Subject: **Request for Modification to the Section 404 Individual Permit and Section 401 Water Quality Certification** for the proposed Greensboro Eastern Loop from US 70 Relocation to SR 2303 (Lawndale Drive), Guilford County, Division 7. WBS Element No. 34821.1.1, TIP Nos. U-2525B and U-2525C.

U-2525C Modification Drawings
Greensboro Eastern Loop from US 29 north of
Greensboro to SR 2303 (Lawndale Drive)
34821.1.1

PERMIT DRAWINGS
SHEET 1 OF 8

PERMIT DRAWINGS
 SHEET 3 of 8

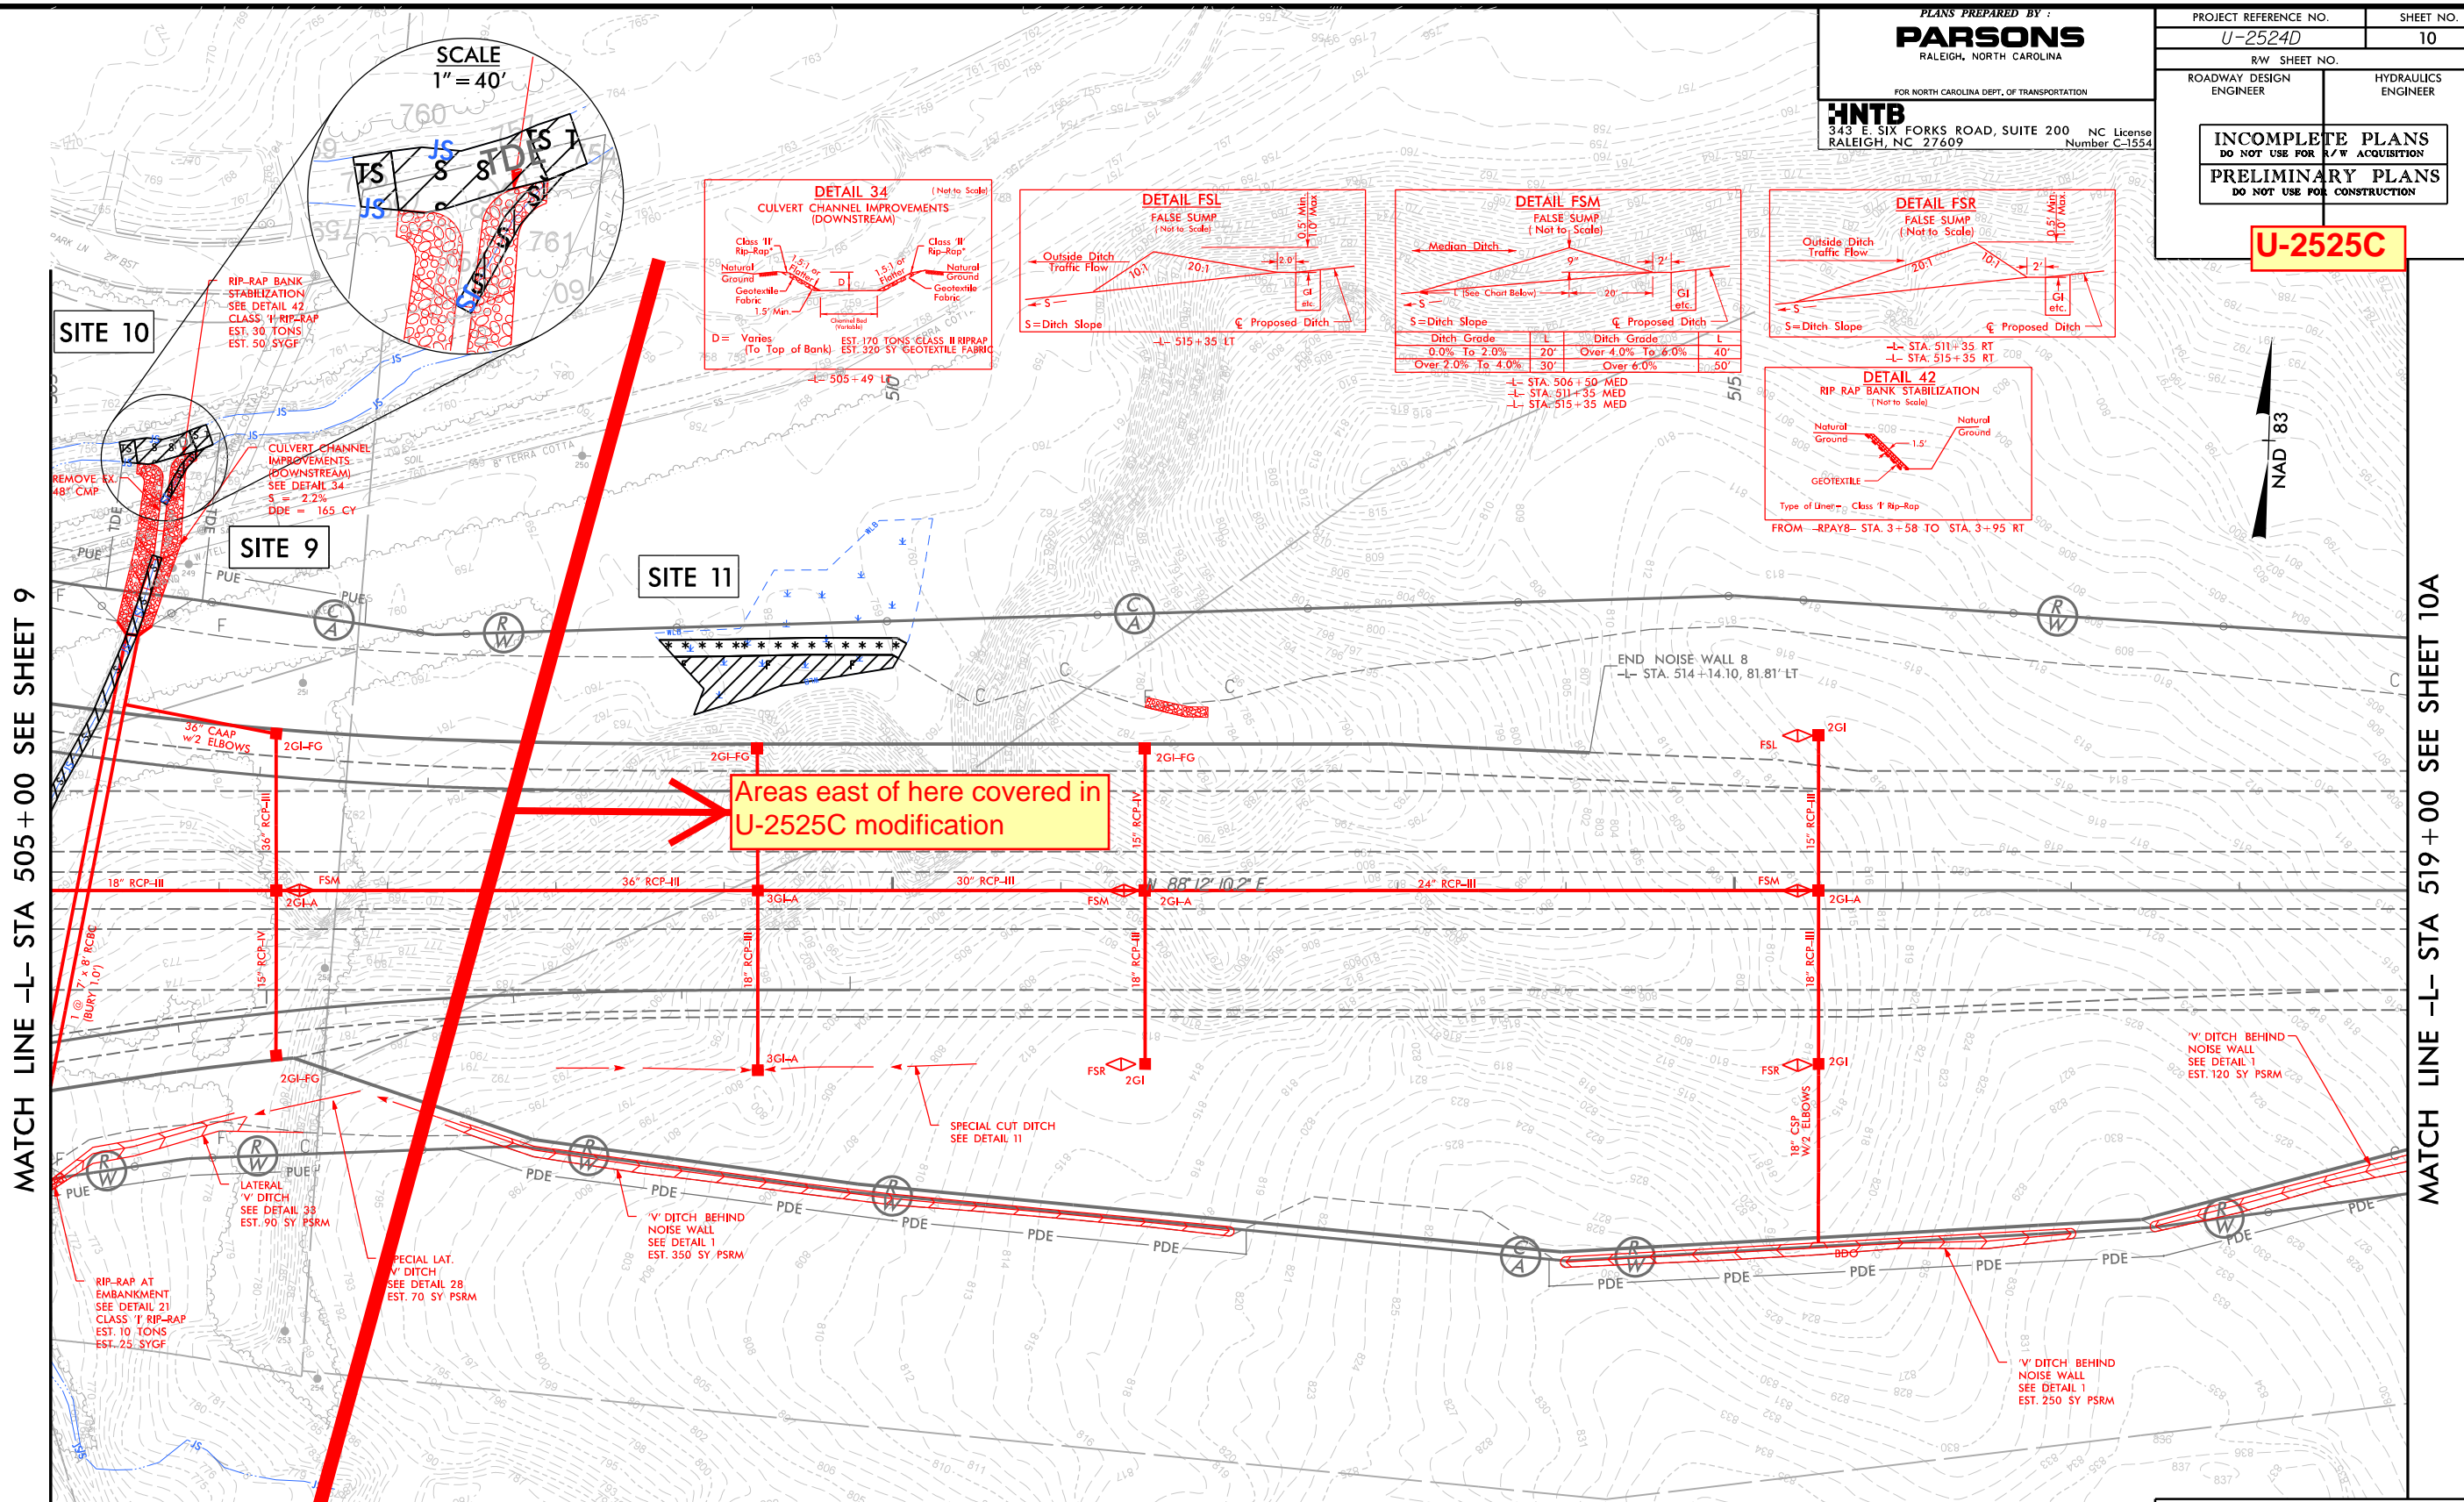
Permit Site 11: As a result of the new roadway slopes from the proposed bypass, there will be 0.05 acre of wetland fill and 0.03 acre of mechanized clearing in wetlands to WR.

PERMIT DRAWINGS
 SHEET 6 of 8

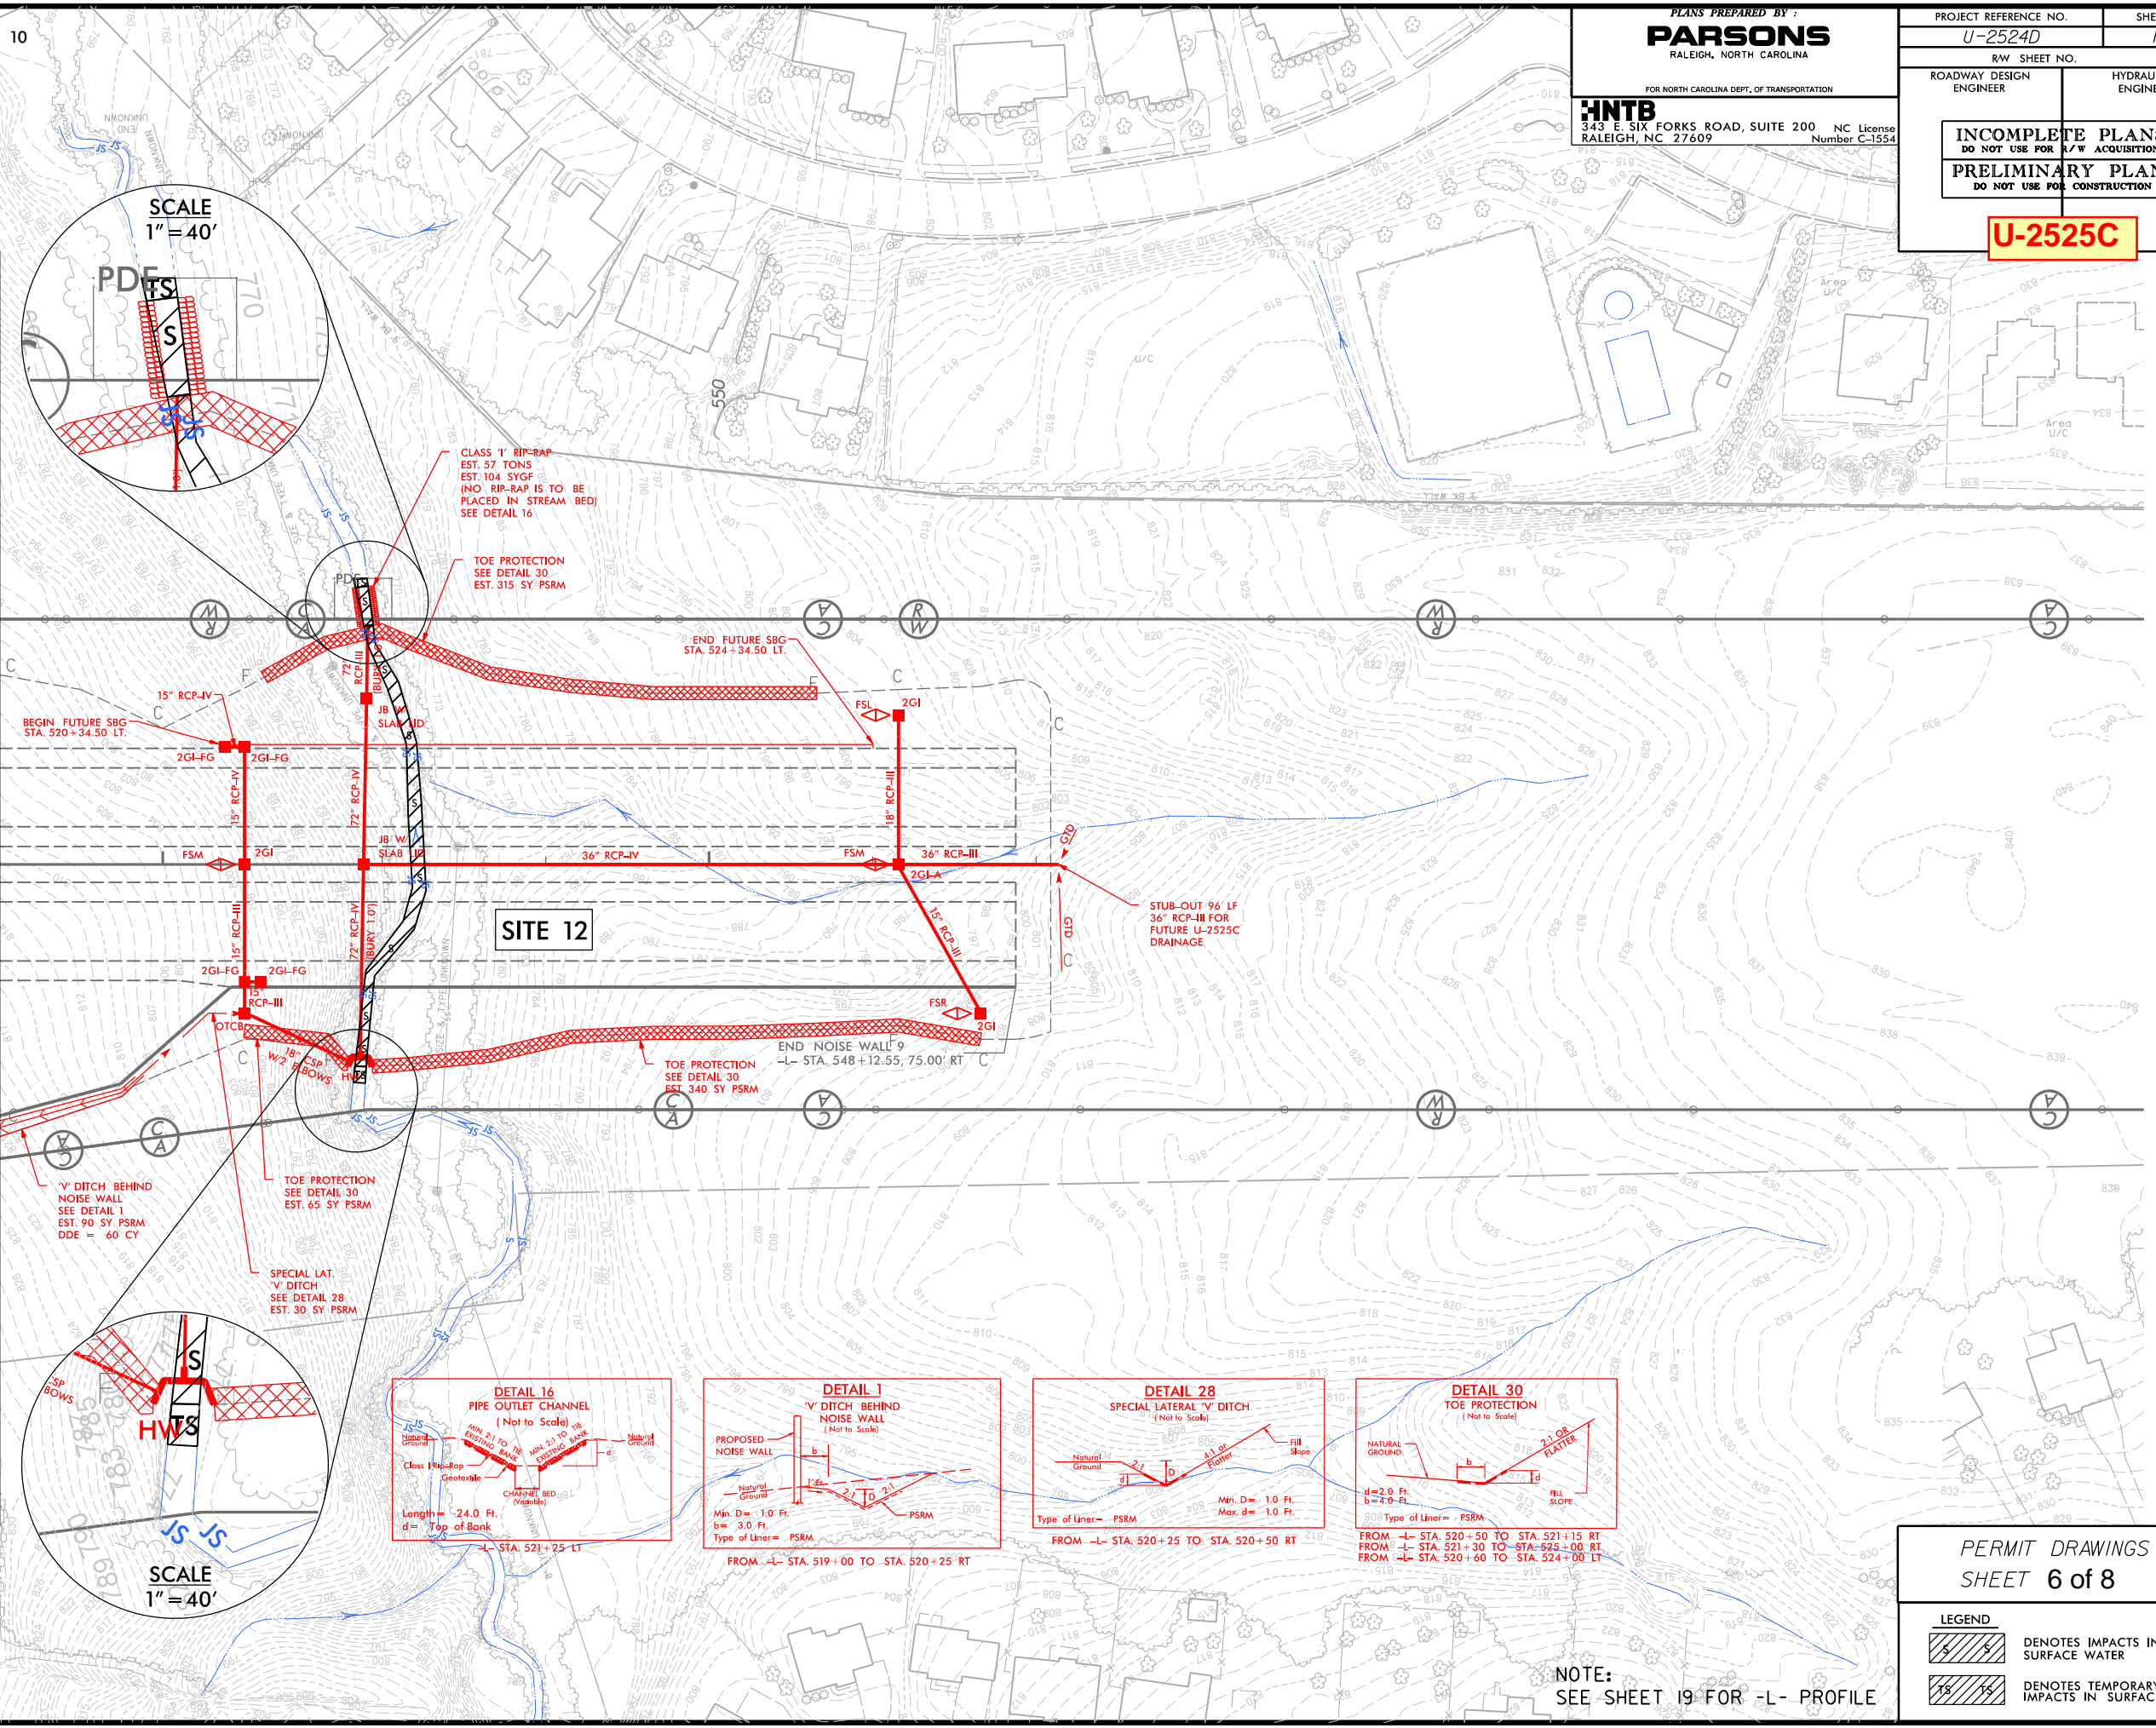
Permit Site 12: A new 72" RCP will be installed to carry SBA under the proposed bypass. There will be 284 linear feet of permanent impacts, <0.01 acre (15 lf) of temporary impacts and 24 lf of bank stabilization to SBA associated with this activity.
